Planning Commission Staff Report

Description: P.Z. 02-2022: River Crossings (Holman Motorcars St. Louis): A request to amend development criteria within a site-specific ordinance for a 15.841-acre tract of land zoned "PC" Planned Commercial District located northeast of the intersection of Chesterfield Airport Road and Public Works Drive (17U24066; 17U240077; 17U240088; 17U52006; 17U520072; 17U520171; 17U520182; 17U520193).

RE: P.Z. 02-2022 (River Crossings Ordinance Amendment)

Figure 4: Sign Plan

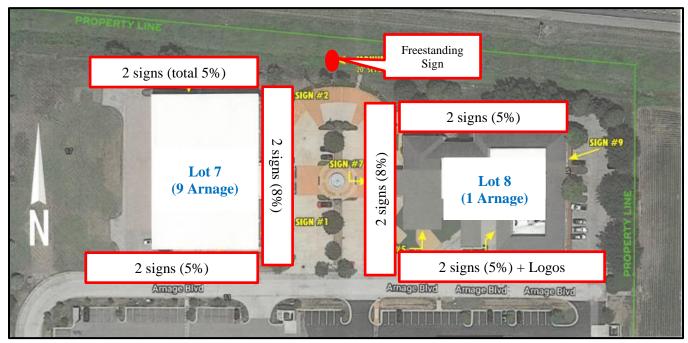
3. Please be advised, the location of the proposed freestanding monument sign along I-64 is not shown on the most recently approved Amended Site Development Section Plan. Additionally, the sign is shown to be located in a stormwater master channel, as well as within structure setbacks. If this Ordinance Amendment is approved, an Amended Site Development Section Plan will be required and reviewed against the site specific ordinance and the Unified Development Code to ensure compliance with both.

SIGN ELEVATION @ SERVICE CORRIDOR: 3/16" = 1'-0"

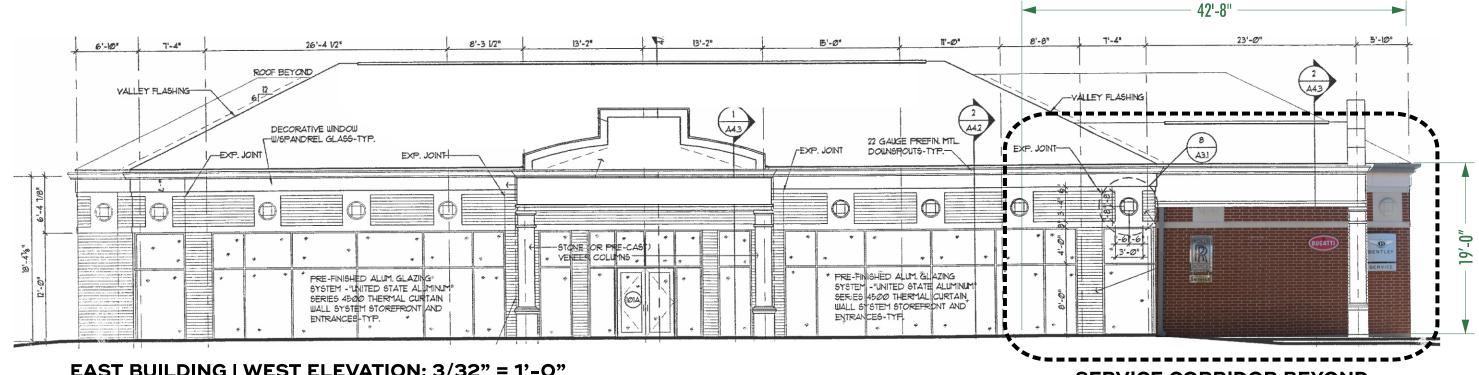
Currenty there is no maximum number of logos at the service entrance at 1 Arnage. Provide the maximum allowed or notate that there is an unlimited amount permitted.

Each exterior wall will be allowed a maximum of two signs. These wall signs shall not exceed a combined total of 5% of the wall area on which they are attached. No business sign shall exceed 300 sq. ft. The exception is the interior facing walls between the courtyard at 1 Arnage and 9 Arnage. These two elevations will be limited to 8% coverage including a maximum of two branding signs and additional logo signs at the service entrance at 1 Arnage.

SIGN ELEVATION: 1/4" = 1'-0" (96sf)

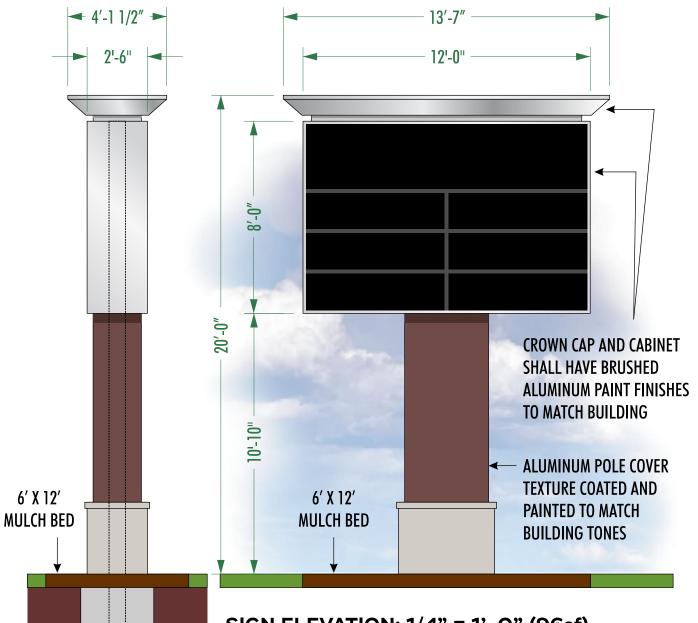
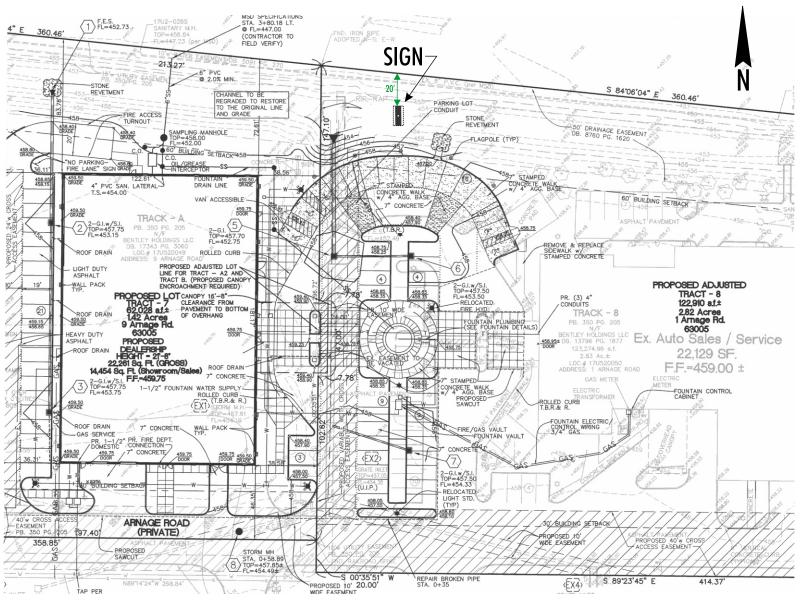
Concerns were raised including but not limited to the impact and appropriateness of the requested monument sign. Provide a response addressing this concern.

Be advised one copy of the draft Exhibit 2 has monument sign permitted along "Chesterfield Airport Road" under I-64 monument. This should state "Interstate 64" in the final submittal.

Response: The proposed sign fronting I-64 needs a height and size appropriate for Interstate traffic. Obviously, all other free-standing signs on the I-64 corridor are much larger and taller. We are requesting the sign facing I-64 to match the Chesterfield Airport Road entrance side (100sf) which has a minimal setback and lower speed limit. The 20' height is necessary so it can be viewed from I-64. This is the only signage Holman has that will be visible to I-64.

The proposed sign fronting I-64 needs a height and size appropriate for Interstate traffic. Obviously, all other free-standing signs on the I-64 corridor are much larger and taller. We are requesting the sign facing I-64 to match the Chesterfield Airport Road entrance side (100sf) which has a minimal setback and lower speed limit. The 20' height is necessary so it can be viewed from I-64. This is the only signage Holman has that will be visible to I-64.
